# SUPPLEMENT TO THE RECORD

## **AC-07-2 & AC-07-3**

Project #1004989

appeals the Development Review Board's approval of a Preliminary Plat, Vacation of Public Easements, Subdivision Design (DPM) Variance; Sidewalk Waiver; and Temporary deferral of Sidewalk for all or a portion of Tract(s) A, Unit 2, Wilderness @ High Desert (to be known as Wilderness Canon @ High Desert) zoned SU-2, HD/R-R, located on High Desert Place NE, between Trailhead Road NE and Embudito View Ct NE, containing approximately 4 acre(s). (F-23) Sheran Matson, DRB Chair

WALDEN TRACT AT HIGH DESERT GRADING PLAN

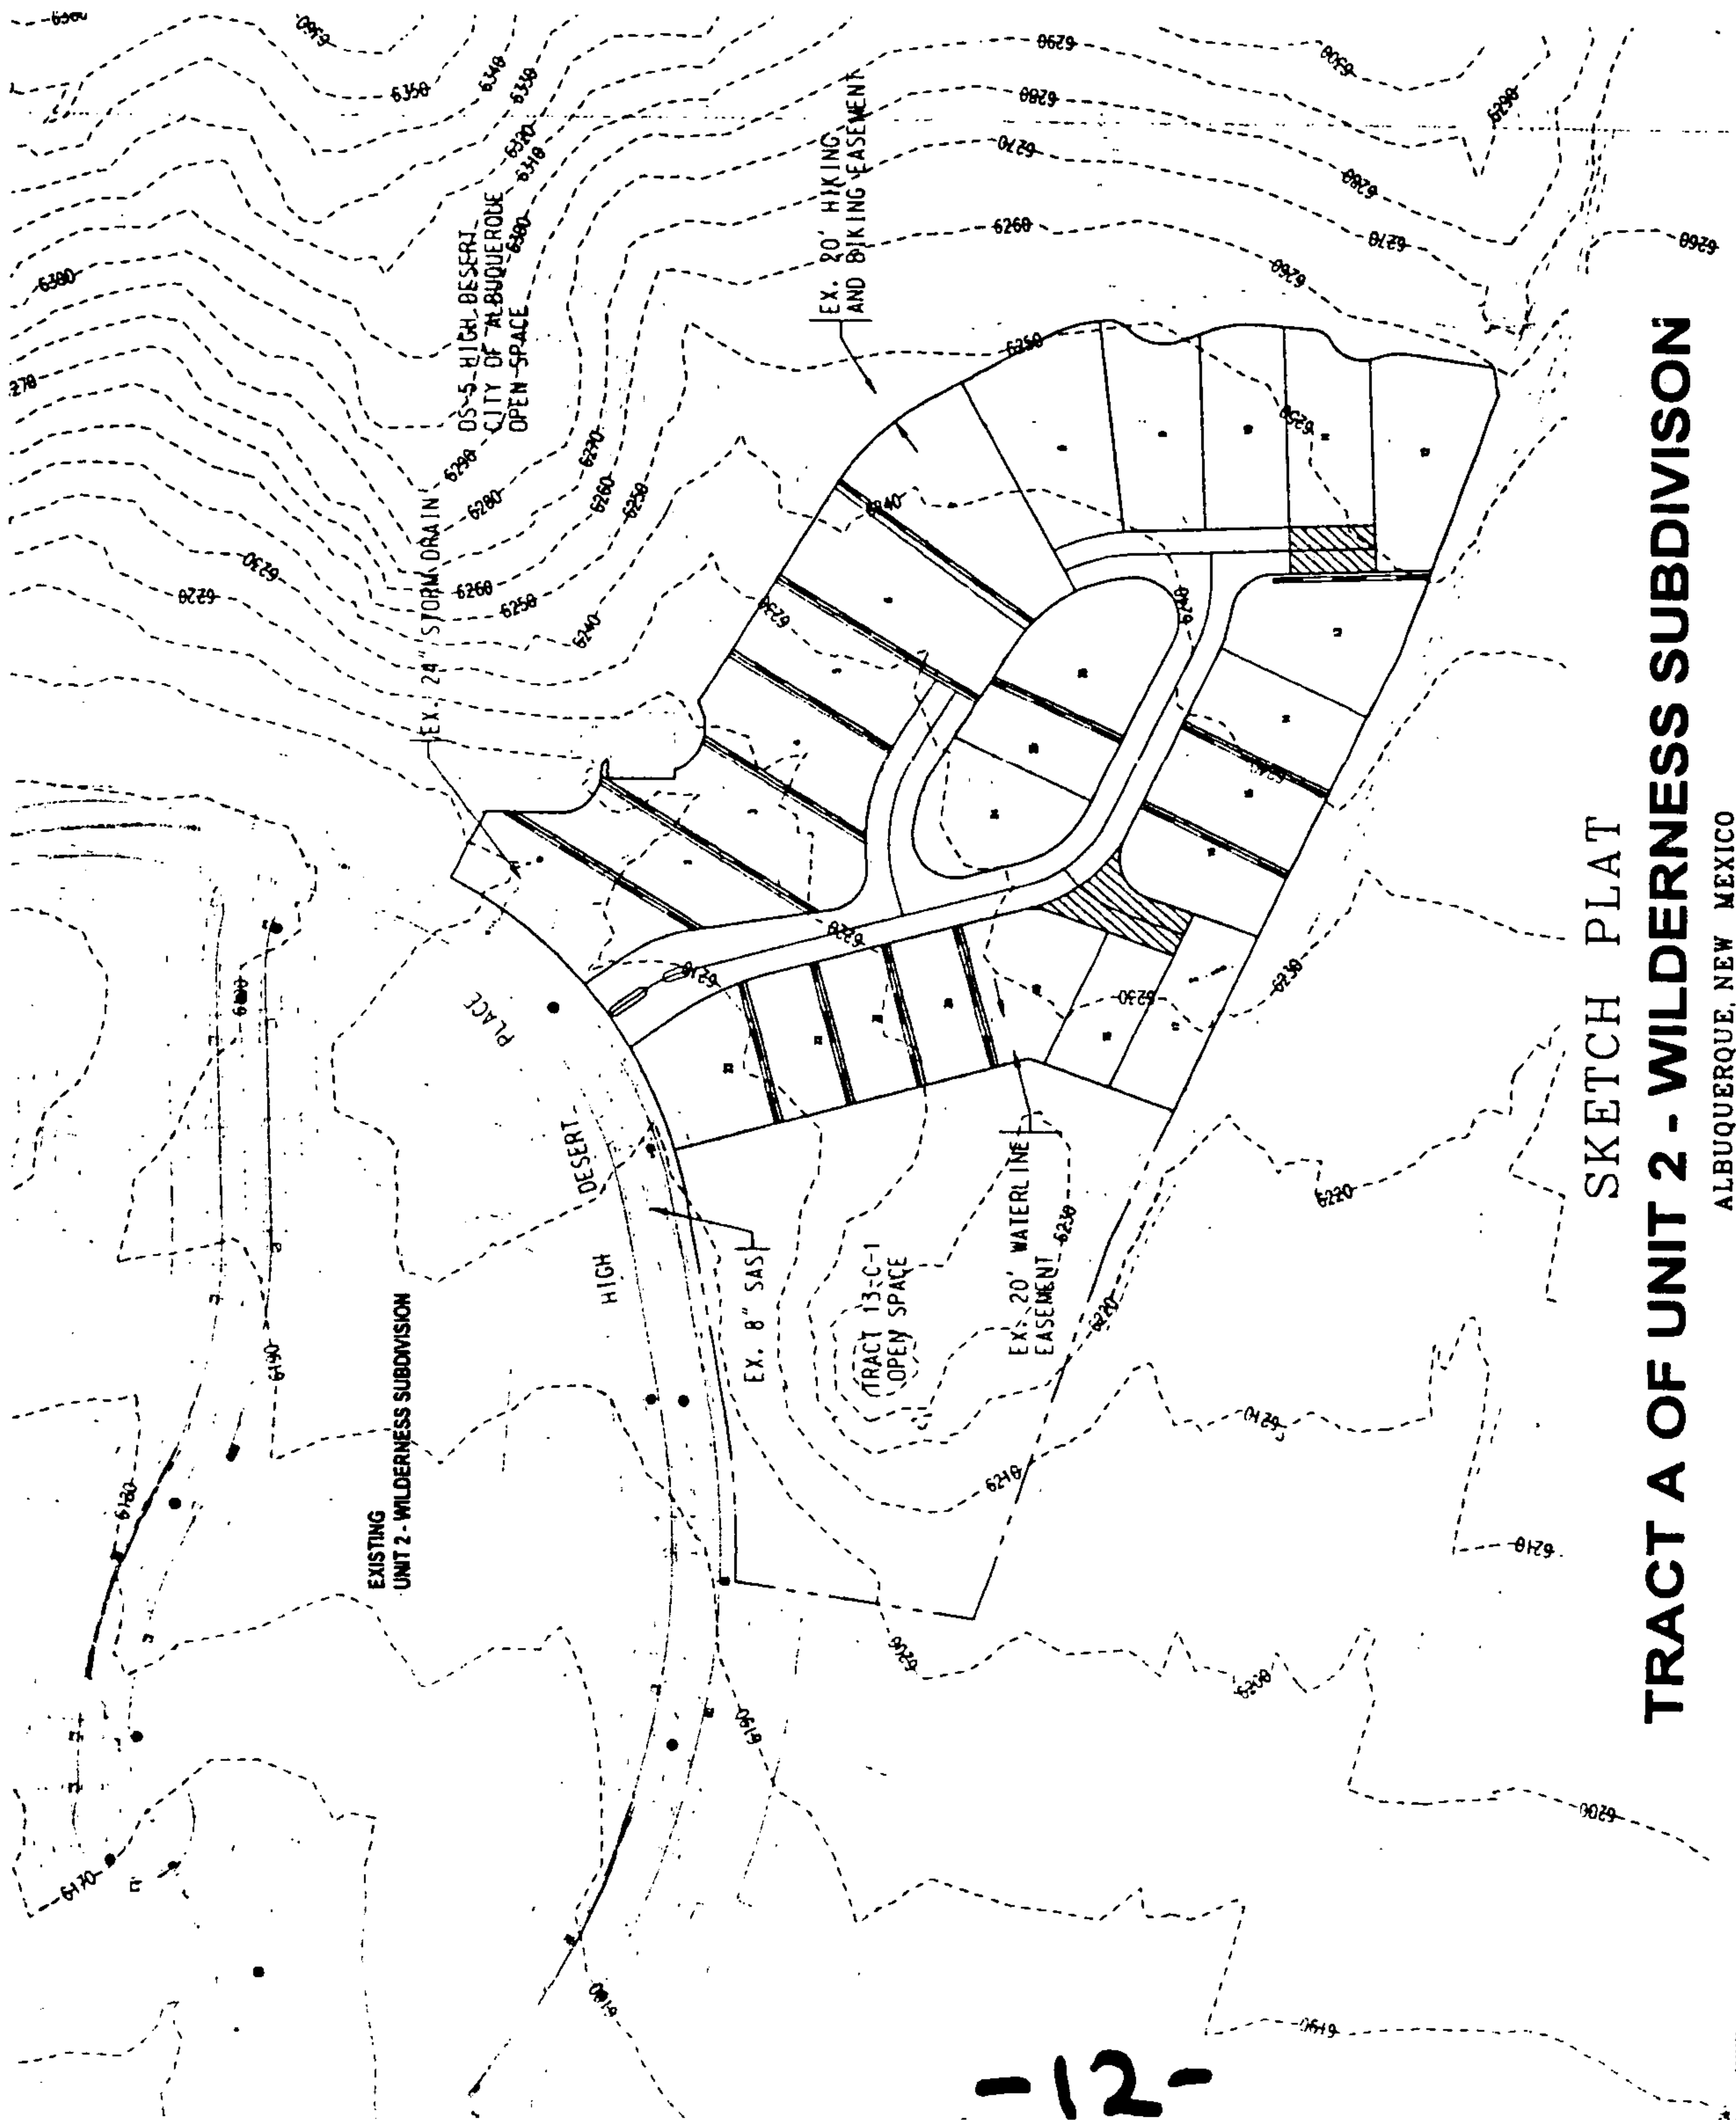
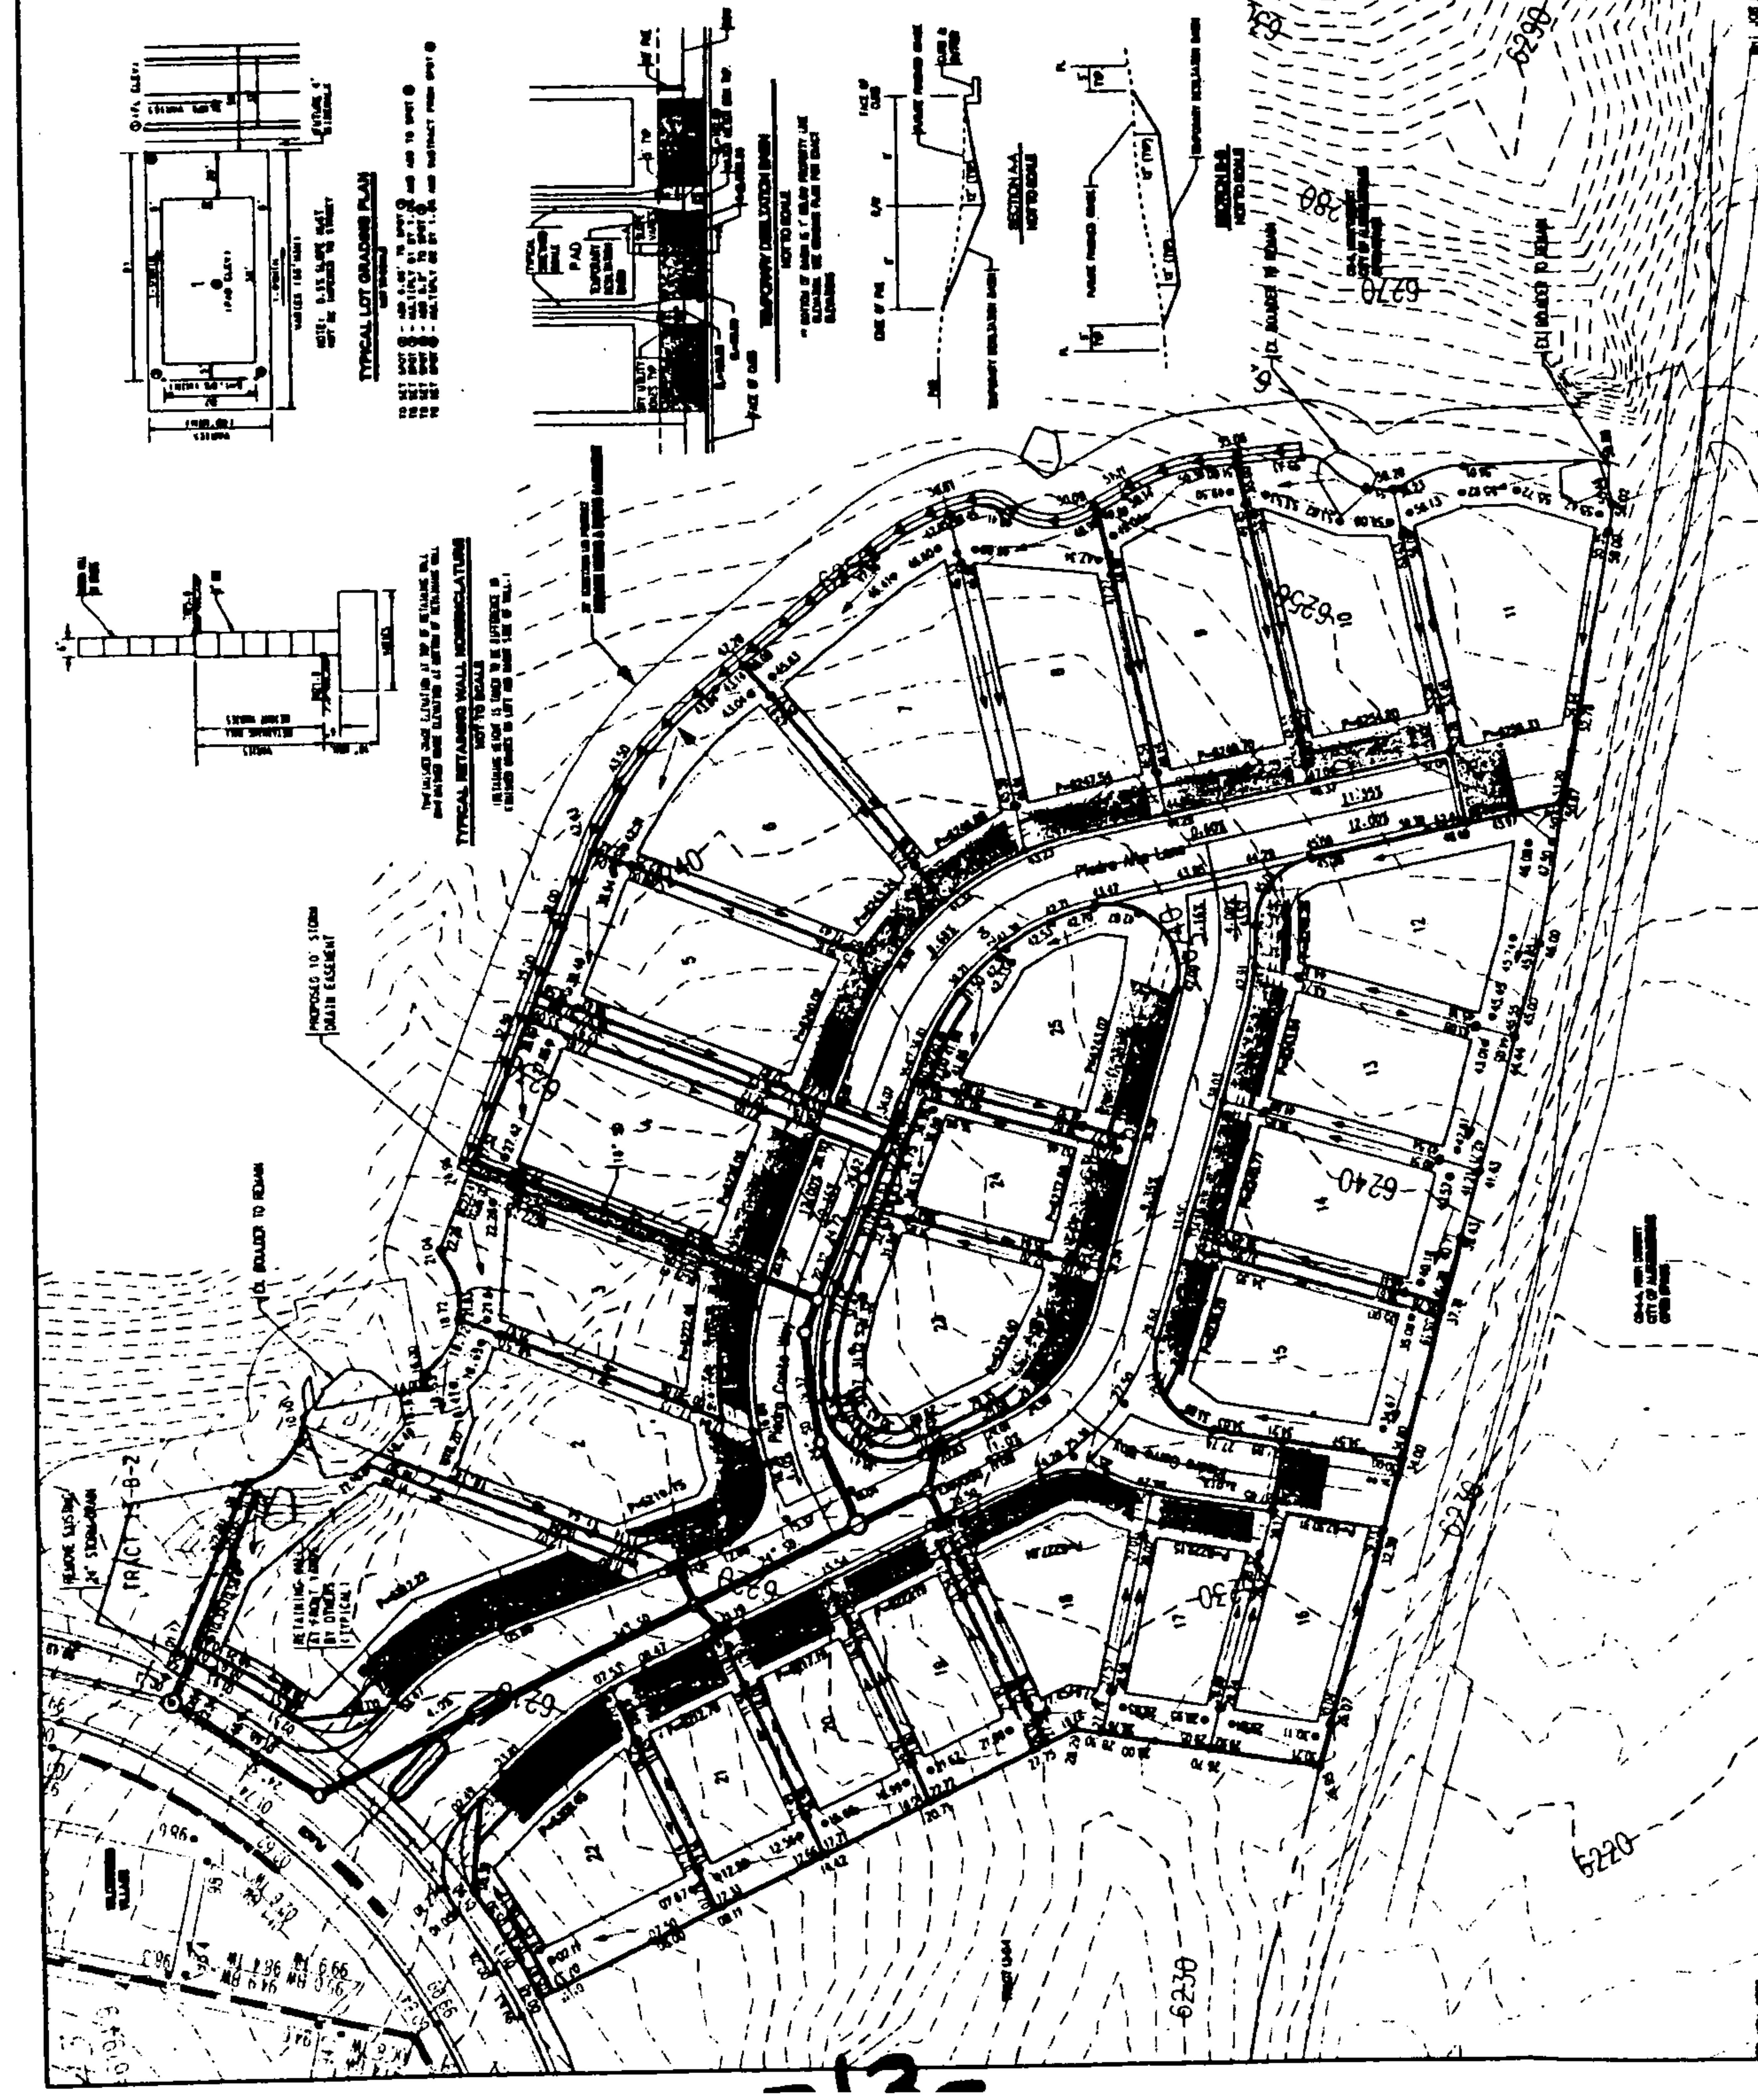
Based upon the information provided in your submittal dated 11-8-06, the above referenced plan is approved for Preliminary Plat approval by the DRB. Once that board approves the grading plan, please submit a mylar copy for my signature in order to obtain a Rough Grading Permit.

This project requires a National Pollutant Discharge Elimination System (NPDES) permit. If you have any questions about this permit, please feel free to call the Municipal Development Department, Hydrology section at 768-3654 (Charles Caruso).

Prior to Release of SIA and Financial Guarantees, an Engineer's Certification of this grading plan will be required.
